ADDENDUM NO. 1

RE: Redevelopment of the Sawmill Site (2 parcels of land on the corner of Riverside Parkway and Winters Avenue, including 1441 Winters Avenue in Grand Junction, Colorado), RFP-5513-24-KF

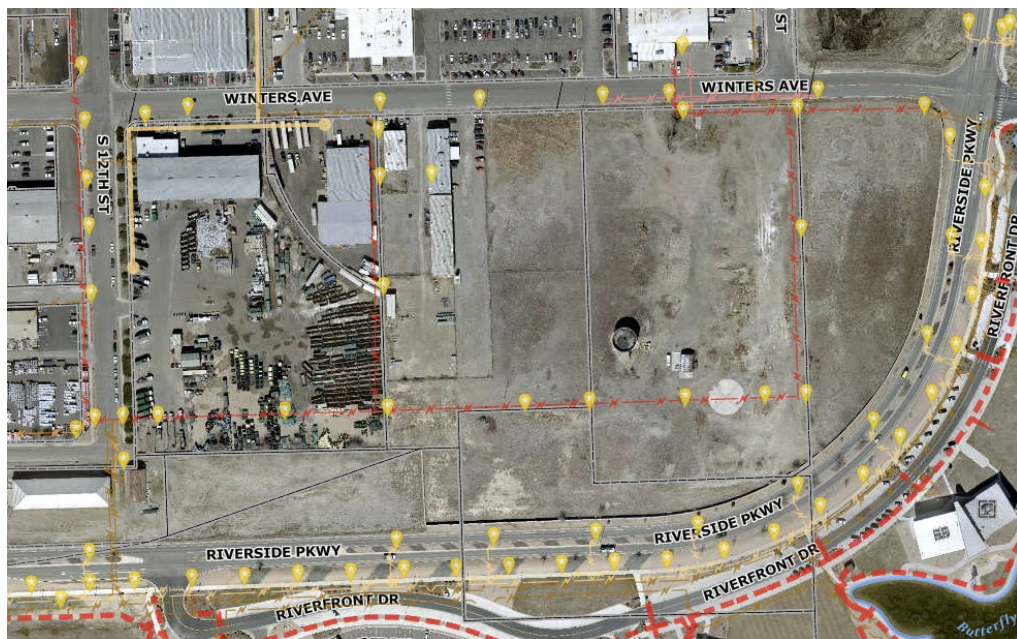
- Where will pedestrian crossings to Las Colonias Park be located?

A: Crossings could include a striped at-grade crossing at the approximate following locations (shown in red).
